▶ **FILE #:** 2-F-11-UR

▶ **APPLICANT:** **ROCKY HILL SHOPPING CENTER**

▶ **PROPOSED USE:** **Shopping center expansion**

▶ **APPROVE the development plan for the addition to the existing eating and drinking establishment and Phase I parking expansion at the Rocky Hill Shopping Center, subject to 6 conditions:**

1 PARTIAL SITE PLAN

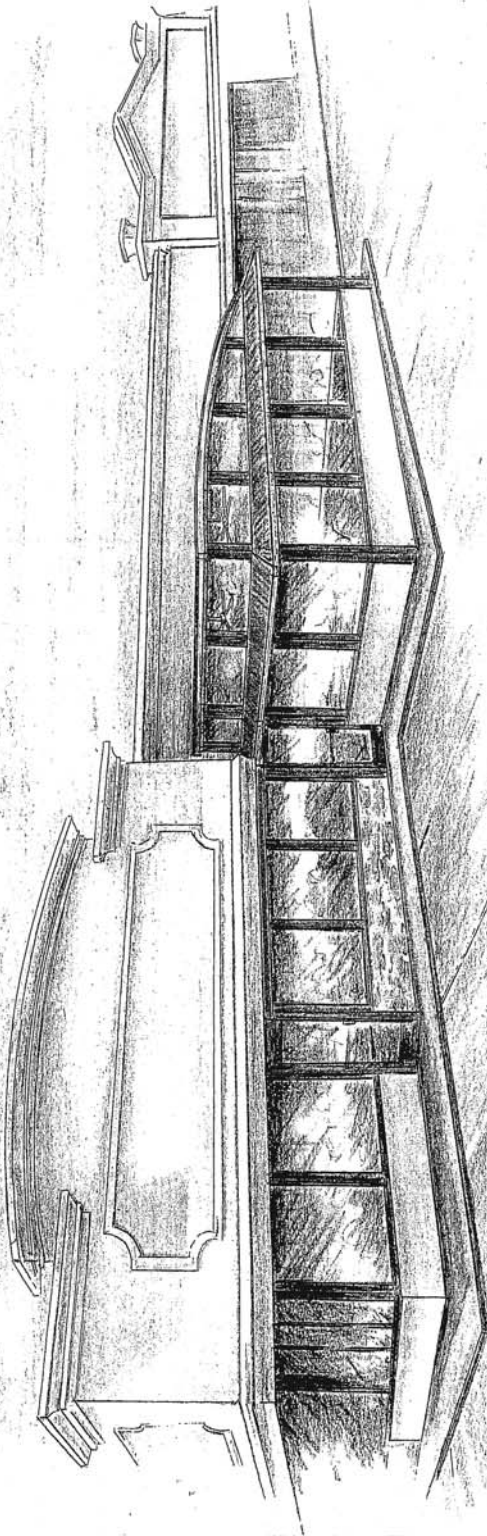
The applicant is proposing to add a covered patio to Rooster's Grill, an existing eating and drinking establishment located in Rocky Hill Shopping Center on S. Northshore Dr. The proposed addition of approximately 790 square feet will be located on the east side of the building and will require the removal of four parking spaces. Even with the addition and removal of existing parking, the shopping center still meets the parking requirements of the Knoxville Zoning Ordinance.

While the addition is proposed as a covered patio, staff's recommended approval would also allow for the addition to be enclosed subject to meeting all building and fire code requirements.

POSSIBLE PARKING
EXPANSION PHASE II
ADDITIONAL 37 SPACES

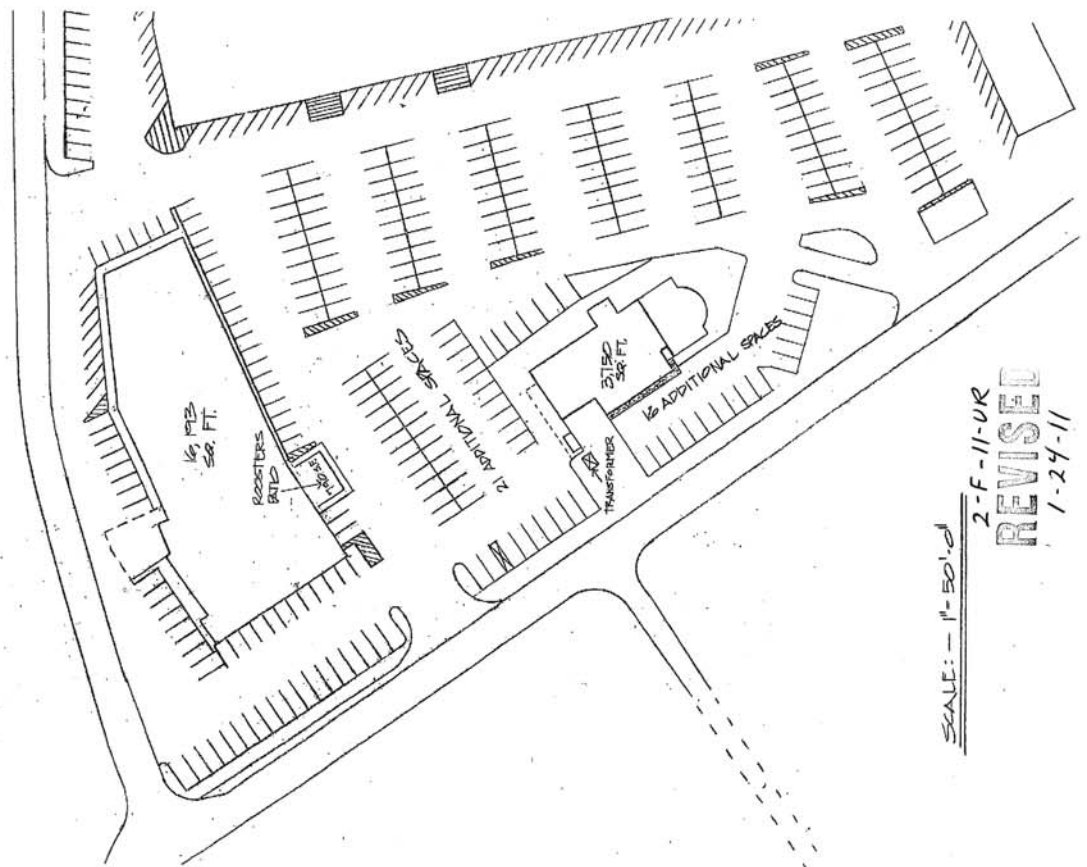
The applicant has proposed two possible parking expansion for the shopping center. Staff is only recommending approval of the Phase I parking subject to moving the parking back from the S. Northshore Dr. right-of-way in order to maintain the required 10' landscape buffer.

POSSIBLE PARKING
EXPANSION PHASE I
ADDITIONAL 21 SPACES

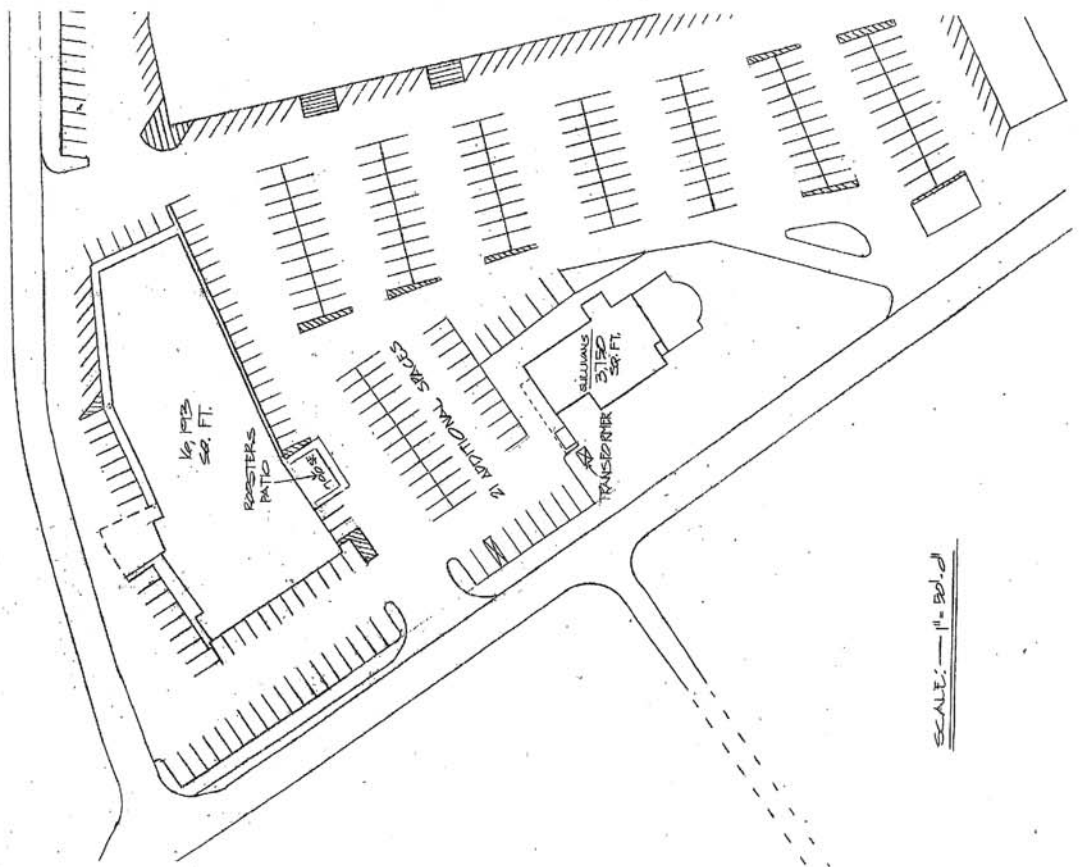
1. Meeting all applicable requirements of the Knoxville Zoning Ordinance
2. Meeting all applicable building and fire code requirements.
3. Meeting all applicable requirements of the Knoxville Engineering Department
4. Prior to moving forward with the Phase 1 parking expansion, submitting a revised scaled development plan to MPC Staff that clearly shows that the proposed parking meets all requirements of the Knoxville Zoning Ordinance including the screening and landscape area required between S. Northshore Dr. and the proposed parking. The revised development and landscape plan shall be approved by MPC staff before

obtaining other approvals. Landscaping shall be provided that will screen the headlights of parked vehicles from S. Northshore Dr.
